RE: Hardee County Landfill

Pending Modification #286397 to Permit No. S025-214306

Thank you for your review and comments concerning the above referenced permit modification for Hardee County. In response to your letter of March 22, 1996 (included in attachment A), the following comments are provided. Your questions are indicated in bold type followed by our response.

FINAL BUILDOUT AND

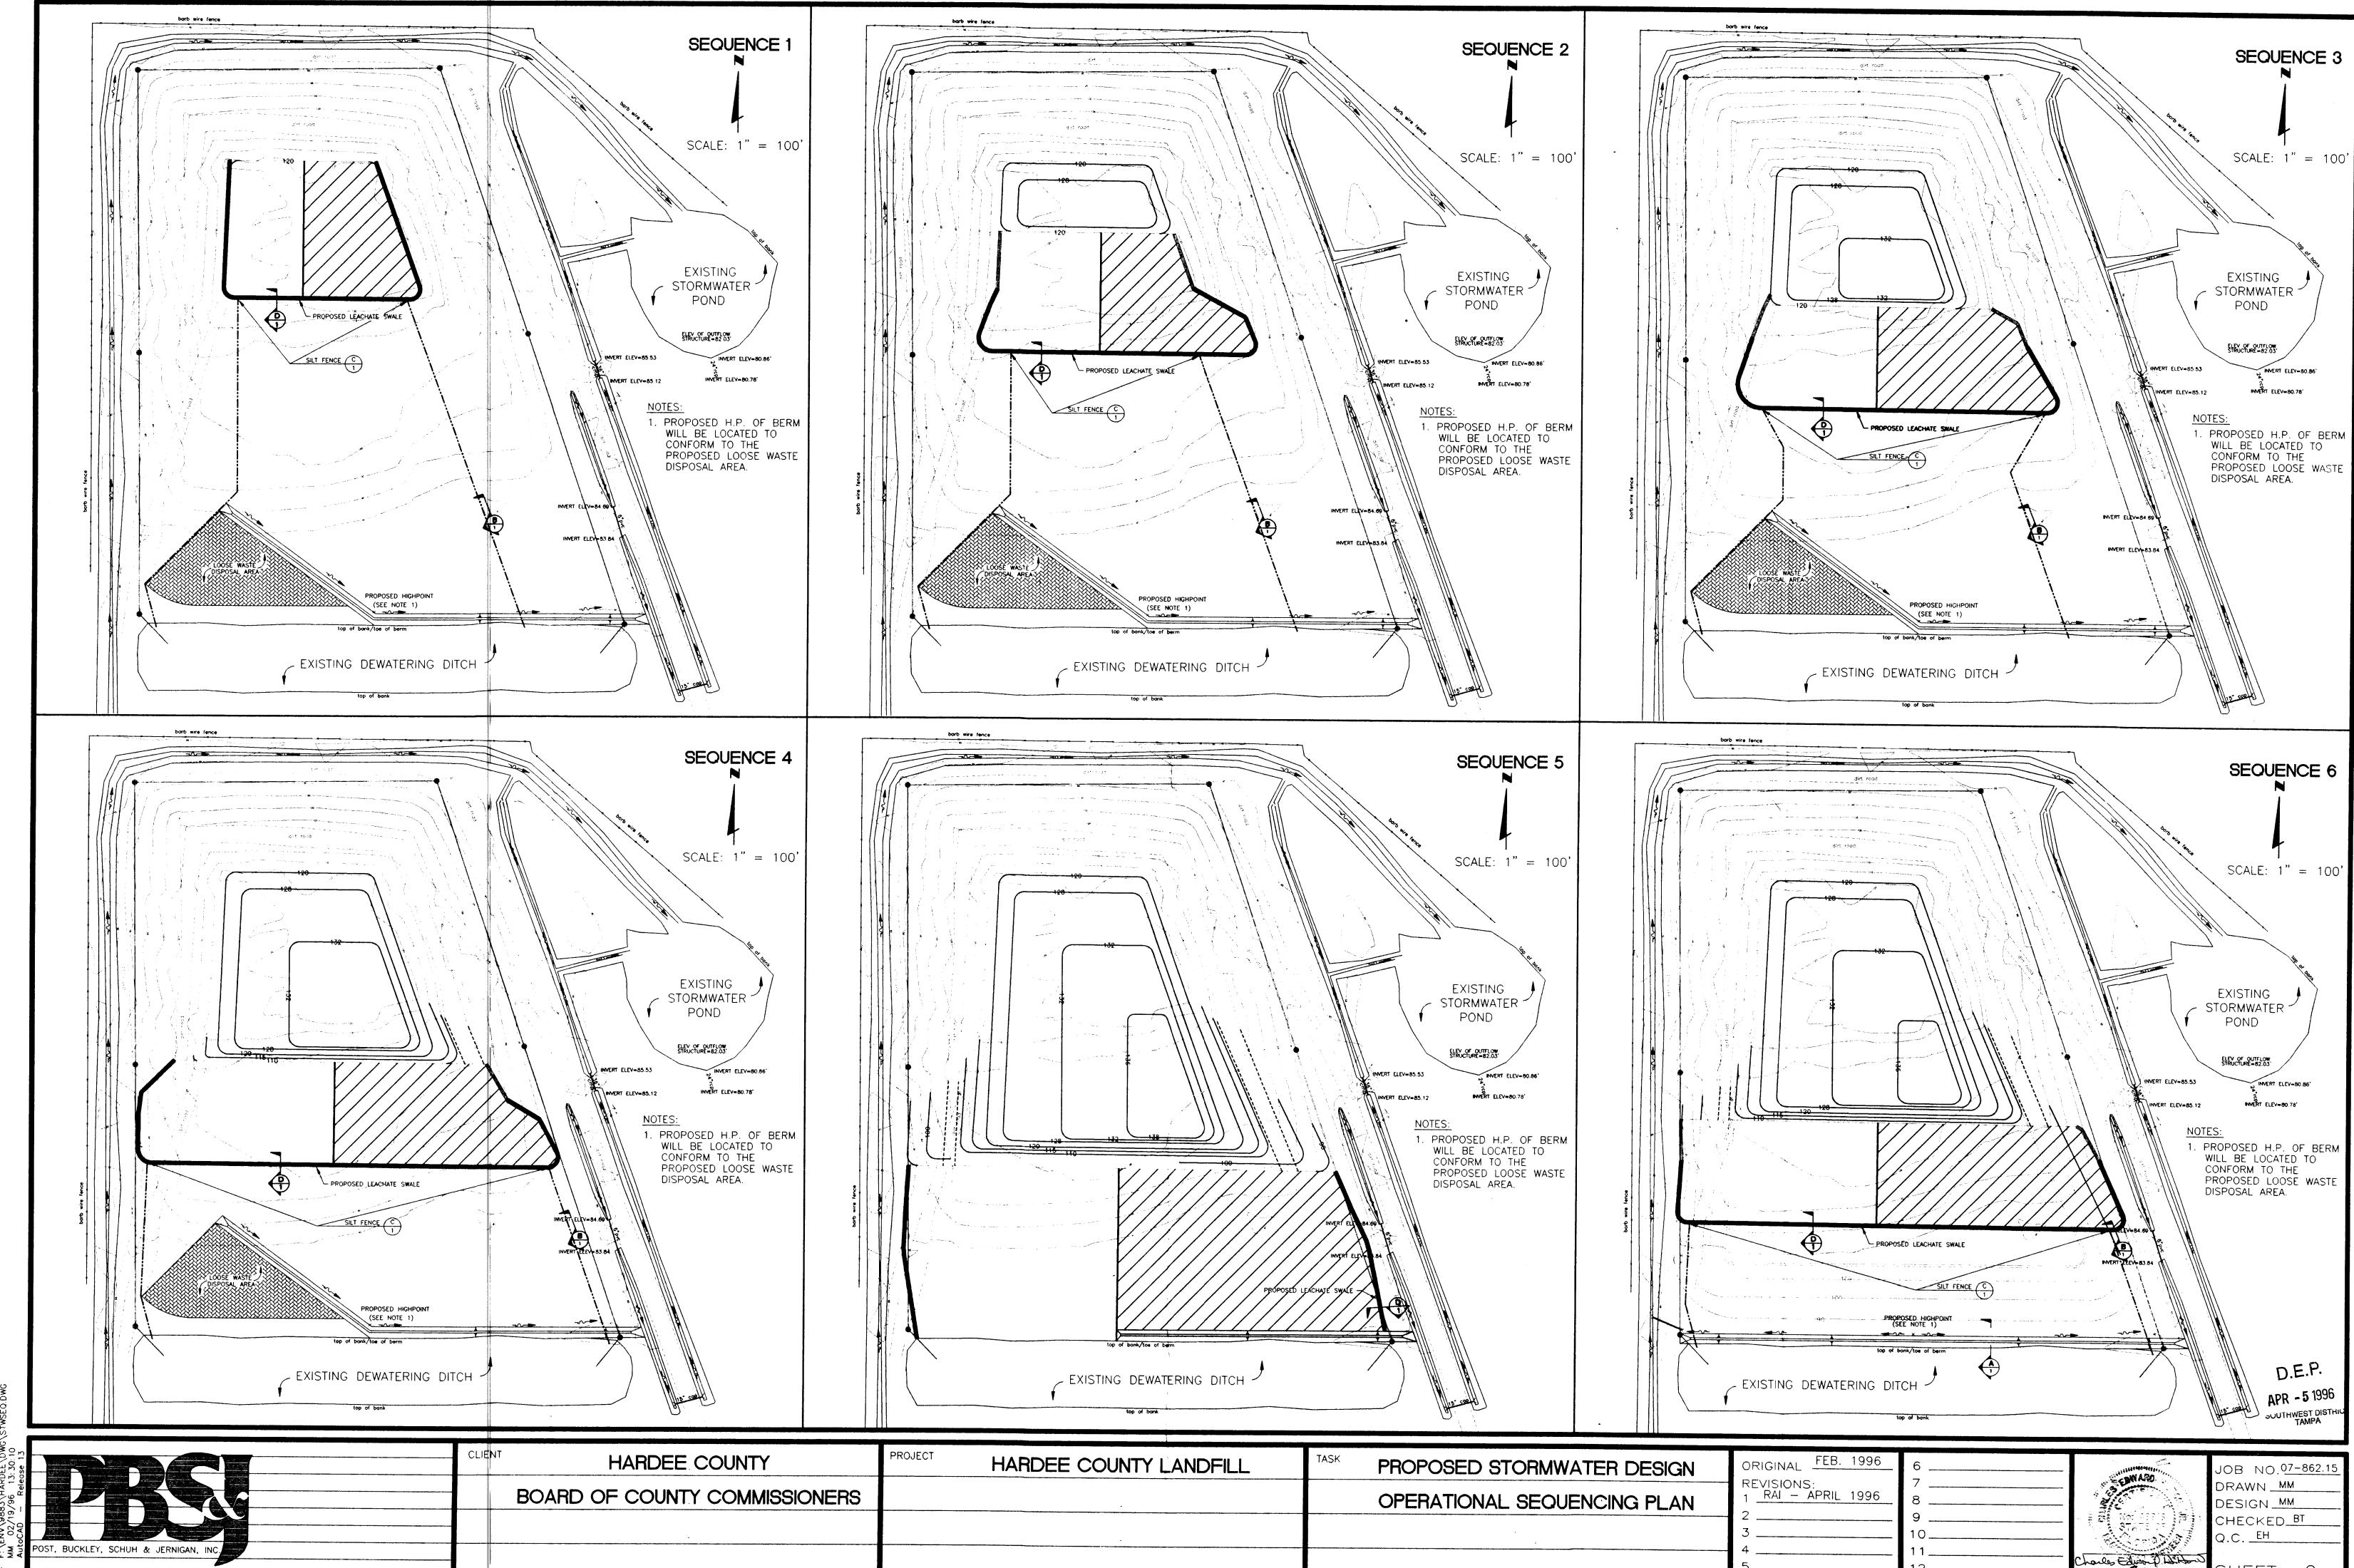
It appears that Section D on Sheet 1 should be referenced back to Sheet 2 where the location of the section is shown. Please note the location of the silt fence detail on Sheet 2.

Please clarify if the area is graded to drain to stormwater and sodded "when the working area in [a] sequence...is reduced to [the size noted on the plans]...and the next sequence begins.

Section D on Sheet 1 was inadvertently referenced back to its own sheet. The detail title target has been revised so that Section D references Sheet 2.

Filled areas will be closed by placing and grading 12-inches of cover material to drain the rainfall to the existing stormwater management system and placing sod as the next sequence begins operation. The information has been clarified on the sequencing descriptions for the proposed stormwater design presented on Sheet 1 of the drawings.
